Access Compliance Report Public Rights-of-Way (Curb Ramps)

Main Street: PURDY_ST Cross Street: BOLSA_AVE Location: SW

ADA ID: RPRK211005133509 Ramp Type: Type 1 - Perpendicular Diagonal Initial Pass/Fail: Fail Overall Compliance: No Severity Score: 16

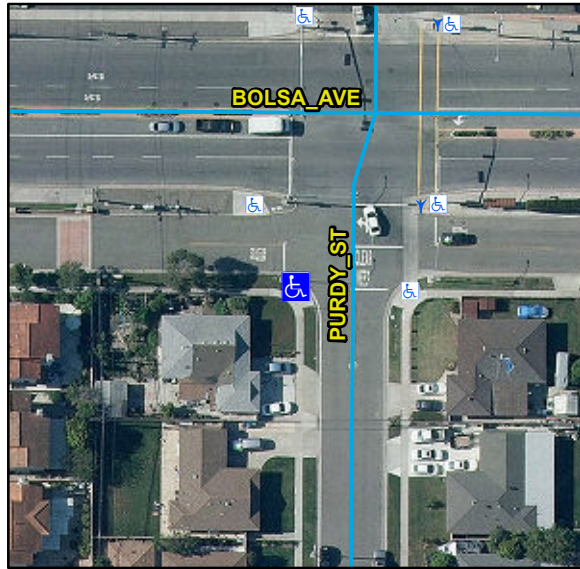
Compliance	Description	Data	Compliance	Description	Data
N/A	Ramp Length (in)	85	N/A	Flare Type LT	
Yes	Ramp Width (in)	48			N/A
No	Ramp Run Slope (%)	11.7	N/A	Flare Slope LT (%)	N/A
No	Ramp Cross Slope (%)	2.1	N/A	Flare Traversable LT	N/A
N/A	Landing Present	N/A	N/A	Flare Type RT	
N/A	Landing Length (in)	N/A			N/A
N/A	Landing Width (in)	N/A	N/A	Flare Slope RT (%)	N/A
N/A	Landing Run Slope (%)	N/A	N/A	Flare Traversable RT	N/A
N/A	Landing Cross Slope (%)	N/A	N/A	DWS Provided	N/A
N/A	Landing Movement Obstructed?	N/A	N/A	DWS Contrast	N/A
	Landing Movement Type	N/A	N/A	DWS Length (in)	N/A
N/A	Landing Shared	N/A	N/A	DWS Full Width	N/A
N/A	Clear Space	Yes	N/A	DWS Offset Left (in)	N/A
N/A	Clear Space To Crosswalk (in)	N/A	N/A	DWS Offset Right (in)	N/A
N/A	Marked Crosswalk 1	No	N/A	Marked Crosswalk 2	No
	Crossing 1 Direction	E		Crossing 2 Direction	N
	Marked Crosswalk 1 Width (in)	N/A		Marked Crosswalk 2 Width (in)	N/A

N/A	Ramp Inside Crosswalk 1	N/A	Yes	Ramp Inside Crosswalk 2	N/A
	Crossing 1 Slope (%)	5.8		Crossing 2 Slope (%)	1
	Crossing 1 Cross Slope (%)	0.5		Crossing 2 Cross Slope (%)	3.3
N/A	Gutter Ponding	N/A	No	Curb Slope	7.9
Yes	Gutter Lip Height (in)	0		Road Run Slope (%)	2.7
N/A	Gutter Run Slope (%)	N/A		Road Cross Slope (%)	0.6
N/A	Gutter Cross Slope (%)	N/A			
Yes	Overall Surface Condition: Acceptable		Yes	Perp Joint Present	Yes
	Cross Gutter Present?	No		Spandrel Present?	No
	Replace Cross Gutter?	N/A		Replace Spandrel?	N/A

Possible Solutions:

Remove & Replace Curb Ramp With Two New Directional Ramps or Equivalent.
